#### STANDARD FIELD SERVICE BULLETIN

FSB Number	CHRAEFSB2014-98
Author	Rajesh Verma
Date	09/18/2014
Subject	Moto X (2nd Generation) - Skewed Medallion
Model Affected	XT1092, XT1093, XT1096, XT1097
Level Of Repairs	Level 2

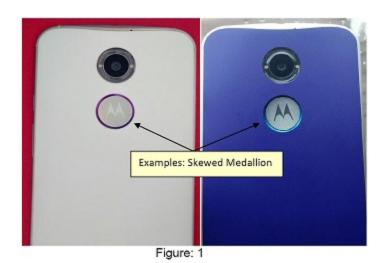
Motorola is aware of a potential field return issue on the Moto X (2nd Generation) product related to Skewed Medallion. Engineering analysis identified that there was no adhesive on the back of the medallion to adhere to the housing or alignment fixture was used during assembly to make sure medallion was aligned correctly. New medallion part with adhesive on the back and alignment fixture has been designed to make sure part is aligned and placed correctly. See below example photos of skewed medallion.

Long Term Action: Since Sep 3, 2014, manufacturing start using new medallion parts with added adhesive on the back and alignment fixture.

- 1. Once replicated, Per Service Manual, carefully disassemble the rear cover from the device to gain access to the medallion as shown above in Figure 1.
- 2. Disassemble the medallion.
- 3. Replace new medallion part with adhesive on the back (Dark P/N: 01018061013 and Light P/N: 01018061014).
- 4. Use alignment fixture (P/N 4-00-U7-10000) to make sure medallion is aligned correctly.
- 5. Reassemble device Per Service Manual.
- 6. Inspect device for medallion alignment.
